# PERMIT

## SEWAGE DISPOSAL SYSTEM

P 46278

REPAIR - EXISTING HOUSE CONVERTING FROM HOLDING TANK TO SEPTIC TANK WITH DISPOSAL FIELD.  
Trench to be 4 feet wide. Inlet 1 foot below original grade. Bottom maximum depth 3 feet below original grade. Effective area begins at 1 foot below original grade. 2 feet of stone below distribution pipe.

# 15781 Colson Property

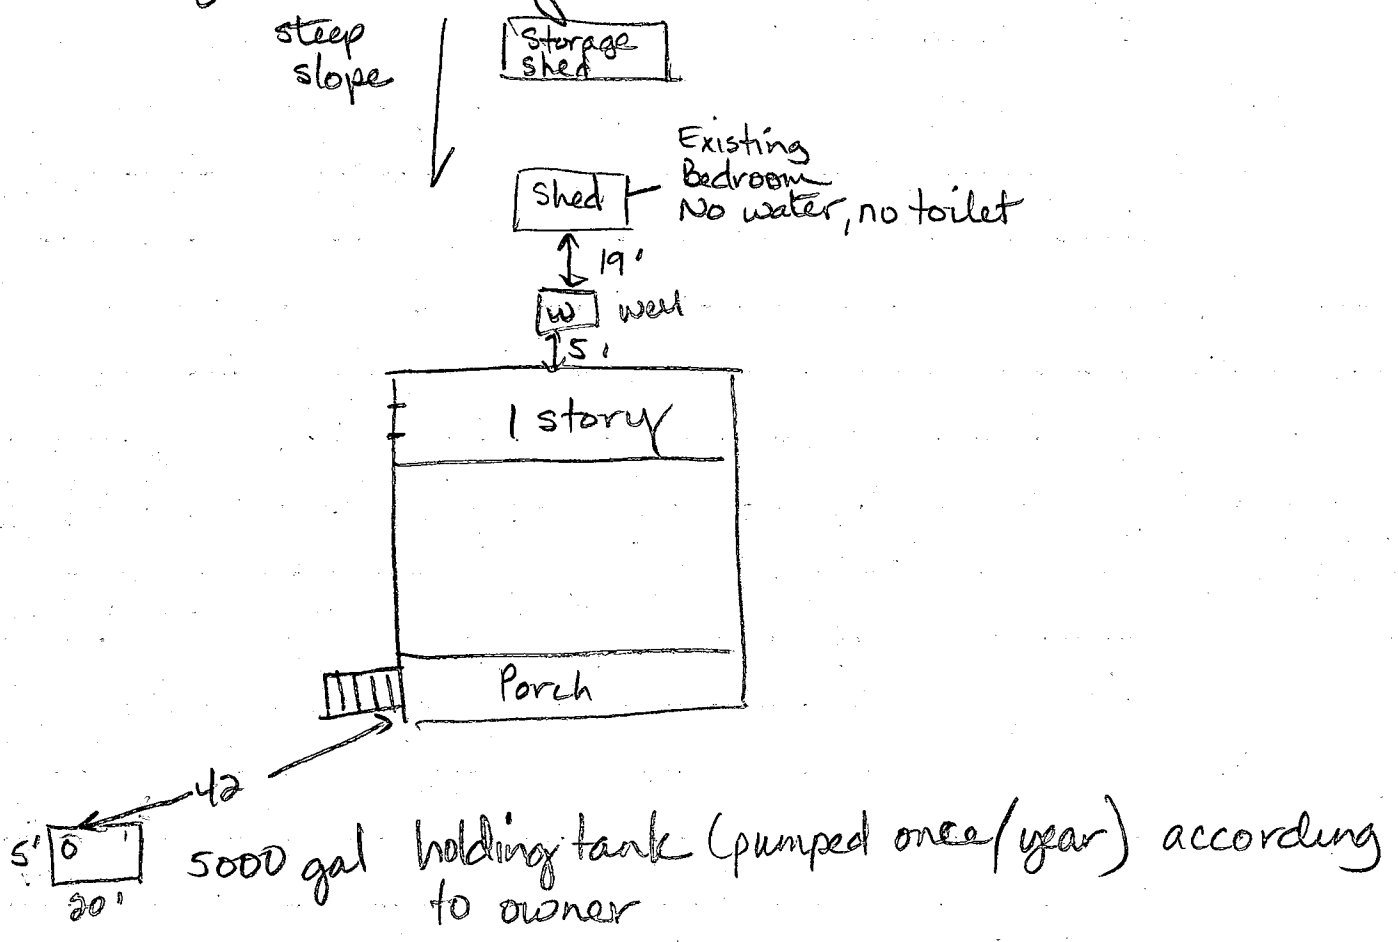
Existing well is cased but set in a pit 4 ft deep. No cap over casing, just bricks on top of well with line running into casing. Box sits above grade to keep rain out. Well about 50 ft deep.

Want to extend addition over top of well w/ cantilever opening facing toward back of building.

Holding tank catches sink water. No shower or bathtub in home.

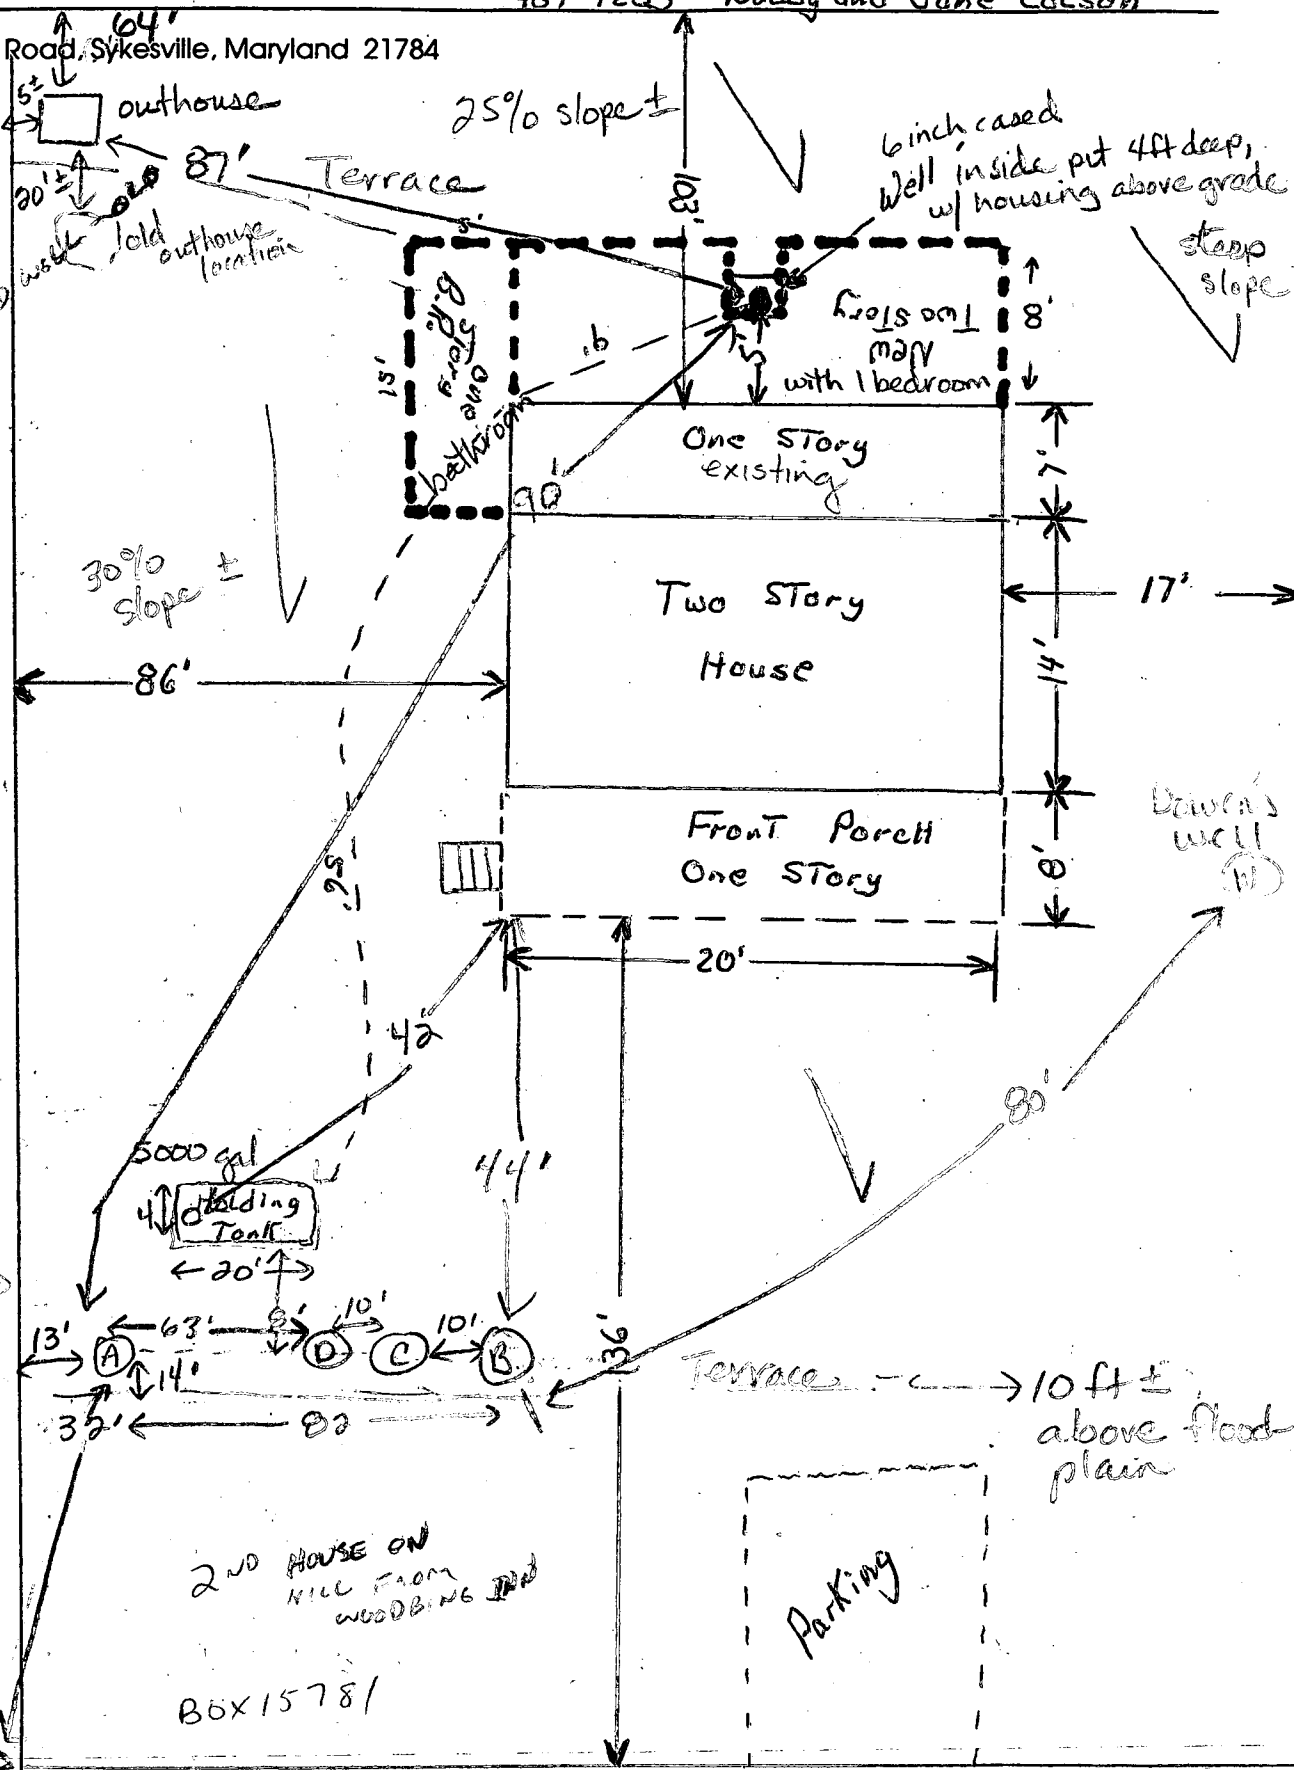
Pre-wet		1st inch		2nd inch	Min/Sec
A	4.0 S	3:05:20	3:07:40	3:07:40	3:12:00	4:20	
	6.5' M	3:08:00	3:08:45	3:08:45	3:12:40	3:55	
	12.0 D	Bottom	(No structure apparent)			ok	
B	3.0 V	(Rocky at 2.0 ft)				Fail	
C	6.0 V	(Rocky at 4.0 ft)				fail	
D	10.0 V	(Rocky at 4.5 ft, slight structure)				Marginal

- 0-1.0 Br s c l  
 1.0-4.0 Br s c l, trace of rock fragments < 10%  
 4.0-12.0 Br mica ss s l, some rock fragments  
 < 35%  
 12.0 Bottom ok

- 0-2.0 Br s c l  
 2.0-3.0 Br sa s l, large rock frags < 85% (phyllite/  
 slate)  
 3.0 Bottom (not refusal but very rocky)

- 0-1.0 Br s c l  
 1.0-4.0 Br mica sa s l, some rock fragments, < 10%  
 4.0-6.0 Br sa s l, large rock frags < 80% (phyllite/  
 shale)  
 6.0 Bottom (refusal)

- 0-1.0 Br s c l, roots  
 1.0-4.5 Br mica sa s l, some rock fragments,  
 4.5-10.0 Gray-br s l, broken rock pieces, < 40%, slight struct  
 10.0 Bottom (Rocky, not refusal) No mottles observed

Recommend: Inlet 1.0 ft, Bottom 2.5 ft,  
4 ft wide trench, 65 ft long  
 $\bar{x} = 4$  minutes 180 sq ft/barn

Add 1000 to 1500 gal septic tank uphill of holding tank, using holding tank as additional area. JEN 8-27-90
